***Development Special Use Permit #2018-0013***  
***Hoffman Town Center, Block 6C – 2425 Eisenhower Avenue***

**PLANNING COMMISSION ACTION, DECEMBER 6, 2018:**

SCREEN WALL  
OPTION

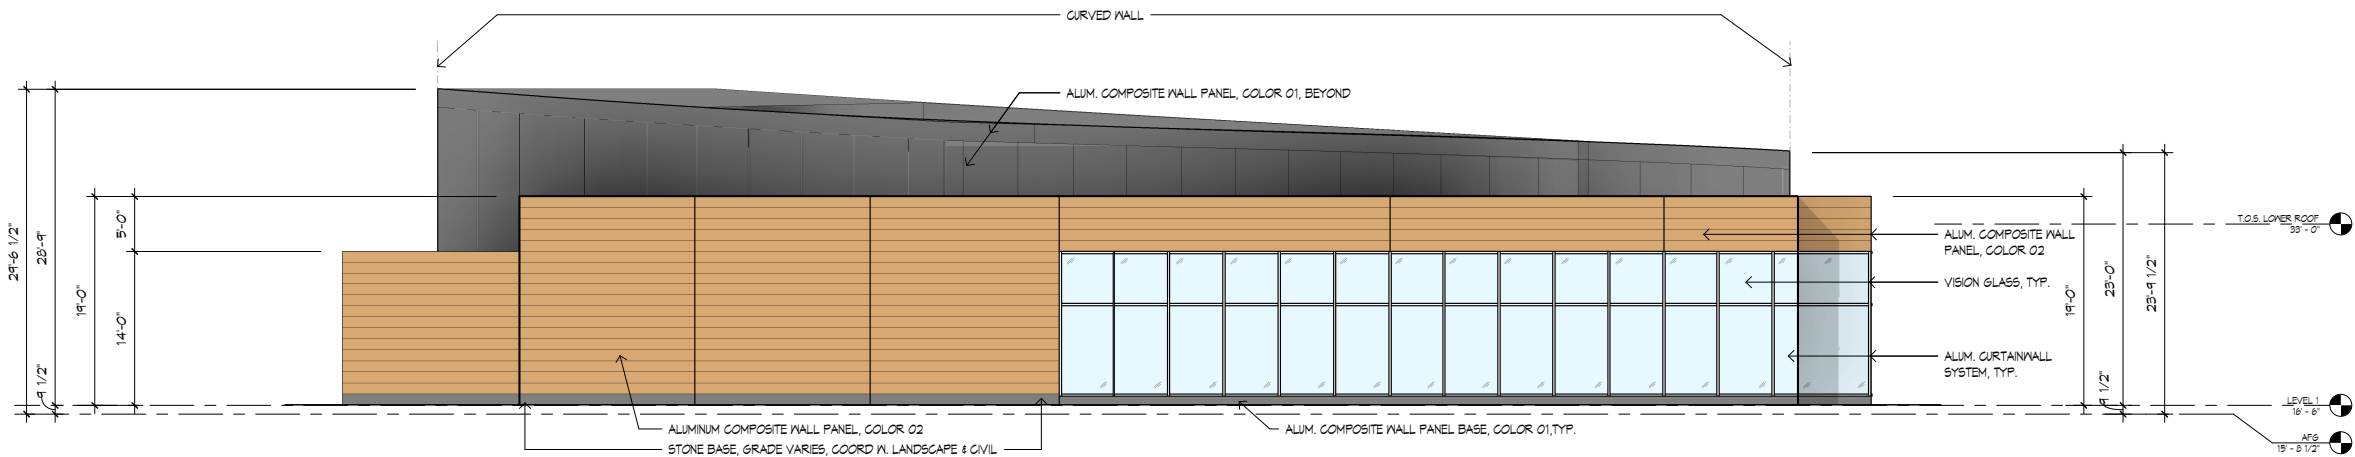
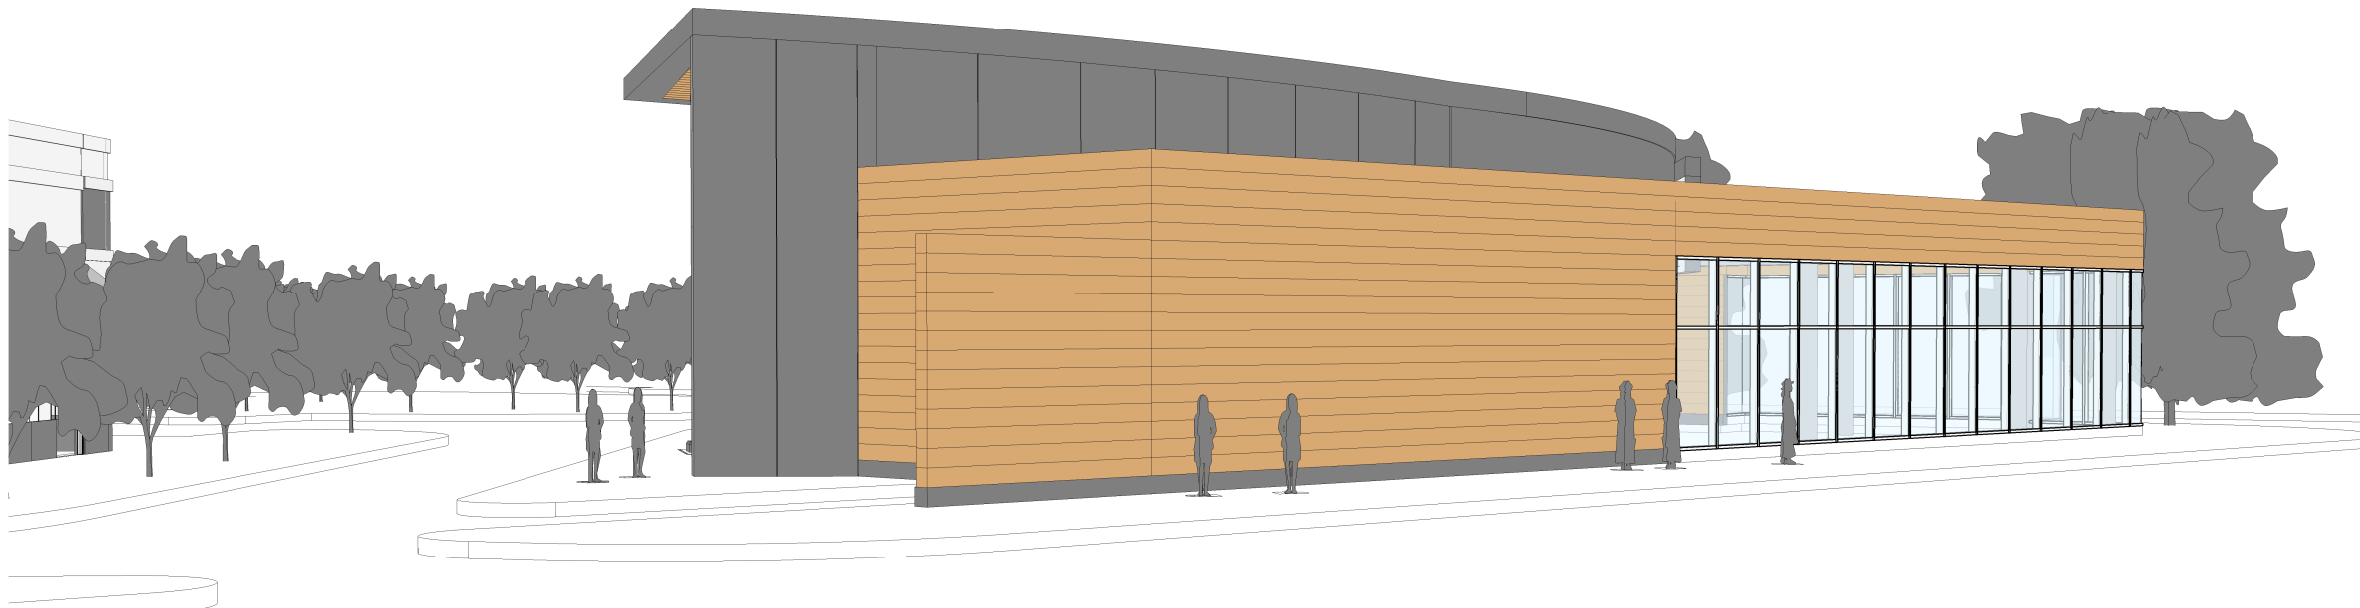
Per the EEDG, loading docks must not be visible from "A" street frontages (Eisenhower Avenue). The DRB's most recent direction to the applicant is to install a loading area screening wall comprised of the same materials as the south building façade that includes a rectangular panel of green screen or similar ornamental metal that is mounted so it floats in the opening between the screening wall and the building. The green screen/ornamental metal work, which could support a climbing vine, would add additional screening as well as prevent inadvertent pedestrian entry to the loading area; but allow enough transparency to reveal the ninety-degree building corner. The DRB also provided direction to the applicant to size the total screening wall so that it will substantially conceal a delivery vehicle when present and that sizing of the screening wall should be studied further by the applicant during the Final Site Plan phases. As previously stated, a screening wall that appropriately screening loading activities is required per Condition #12f. of the Staff Recommendations.

- f. Provide screening of the loading area to ensure that loading activities are not visible from Eisenhower Avenue per the direction of the Carlyle Design Review Board. (P&Z)

**Figure 1: Loading Area Screening Markup**

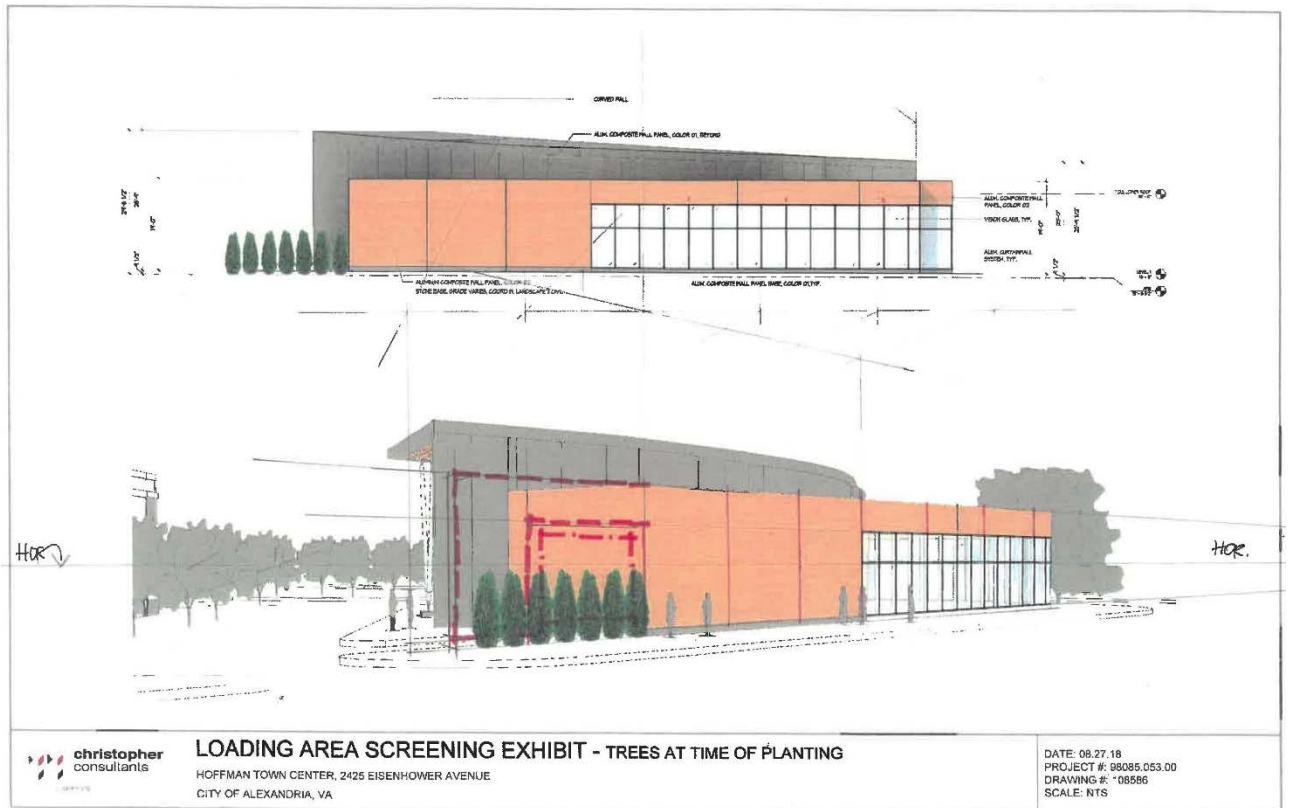
Staff also recommends that the proposed loading area screening be brought into compliance with Section Nine of the Eisenhower East Design Guidelines, as the proposed screening options do not adequately screen the loading area from view from Eisenhower Avenue. Staff recommends that the applicant enhance their screening wall option by matching the wall height of the main building façade and adding a perforated metal or metal architectural element to break the monotony of the aluminum composite wall panels across the south building façade; as shown in Figure 1. Staff also recommends landscape screening for the transformer located near the proposed loading area, which the DRB encouraged at the July meeting.

- Enhance the screening wall option by matching the wall height of the main building façade and adding a perforated metal or metal architectural element to break the monotony of the aluminum composite wall panels across the south building façade (Figure 1)
- Provide screening for the transformer near the loading area on the west side of the building.
